## SERVICE BULLETIN

M-1125A

Safety Recall Code 0106

### FLTRSEI FULLY BRAIDED CLUTCH CABLE REPLACEMENT

Figure 1. Braided Clutch Cables

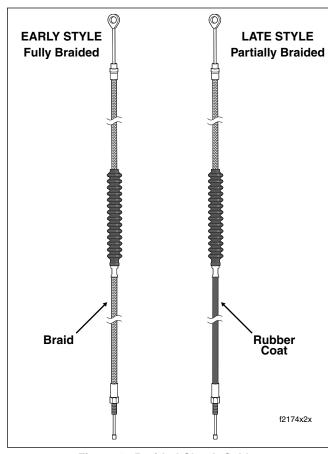
As recently advised in ML-377, Harley-Davidson has learned that there is a safety defect related to the fully braided clutch cable on certain 2000 FLTRSEI Screamin' Eagle Road Glide motorcycles. The fully braided clutch cable may contact the rear brake line and cause the brake line to abrade over time, thereby causing loss of rear brake fluid. The loss of rear brake fluid can cause the loss of rear brake function, possibly without warning, and could cause an accident.

The early style fully braided clutch cable is to be replaced with the late style partially braided cable. The lower length of the partially braided cable is rubber coated to prevent possible chafing of the rear brake line. See Figure 1.

In the interest of motor vehicle safety and customer satisfaction, Harley-Davidson has elected to initiate a voluntary recall (Campaign 0106) to replace both the rear brake line and the early style fully braided clutch cable. See REQUIRED DEALER ACTION to perform the recall service.

- 2. Unthread bolt and remove battery negative cable (black) from battery negative (-) terminal.
- 3. Obtain kit and proceed as follows:
  - Even if no apparent damage is observed, install new rear brake line. See Section 2.10 REAR BRAKE MASTER CYLINDER, REAR BRAKE LINE, REMOVAL/INSTALLATION.
  - Install new partially braided clutch cable. See Section 2.20 CLUTCH CABLE, REMOVAL/INSTALLATION.
